Access Compliance Report

Public Rights-of-Way

Intersection ID: 16392	Main Street: QUEENS_RD_WEST	Cross Street: WELLESLEY_AV	Location: NW
ADA ID: 40C6672AE378	Ramp Type: Perp	Initial Pass/Fail: Fail	Overall Compliance: No
		Severity Score: 12.5

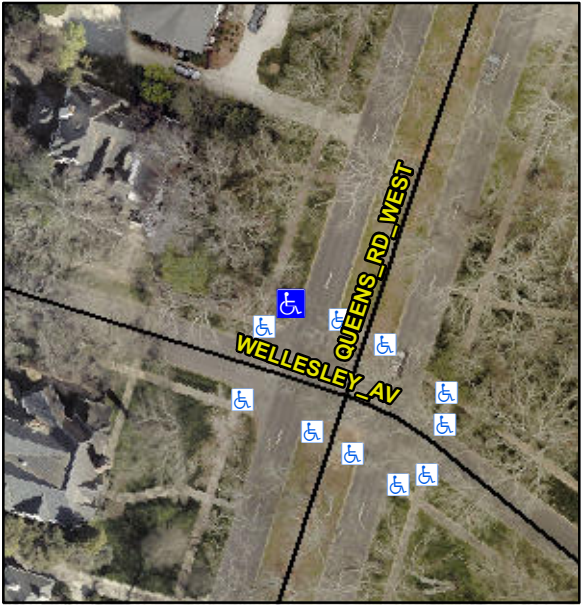
Codes/Mitigation Info/Possible Solution			Field Measurements/Component Compliance		
	Possible Solutions:		Compliance	Description	Data
	Remove & Replace Entire Ramp.		N/A	Ramp Length (in)	52.0
			Yes	Ramp Width (in)	63.0
			N/A	Flare Type LT	N/A
			N/A	Flare Slope LT (%)	N/A
			N/A	Flare Traversable LT?	N/A
			N/A	Landing Length (in)	N/A
			N/A	Landing Width (in)	N/A
			N/A	Landing Slope (%)	N/A
			N/A	Landing X Slope (%)	N/A
<p>Surveyor Notes:</p> <p>N/A</p> <p>PROW/ADA:</p> <p>R304.2.2</p>			N/A	Flare Type RT	N/A
			N/A	Flare Slope RT (%)	N/A
			N/A	Flare Traversable RT?	N/A
			N/A	DWS Provided?	N/A
			N/A	DWS Contrast?	N/A
			N/A	DWS Length (in)	N/A
			N/A	DWS Full Width?	N/A
			N/A	DWS Offset (in)	N/A
			N/A	Shared Landing?	N/A
			N/A	Gutter Ponding?	N/A
			N/A	Gutter Lip Ht (in)	N/A
			N/A	Painted X Walk1?	No
				X Walk 1 Direction	To SE
			N/A	X Walk 1 Width (in)	N/A
				X Walk 1 Slope (%)	3.6
				X Walk 1 X Slope (%)	1.8

N/A	Ramp inside XWalk1?	N/A
			N/A	Ramp inside XWalk2?	N/A
			N/A	Road Slope (%)	N/A
			N/A	Road X Slope (%)	N/A
			N/A	Any Obstructions?	N/A
				Obstruction Type	
			N/A		N/A
			Yes	Surface Condition? (G/P)	Good
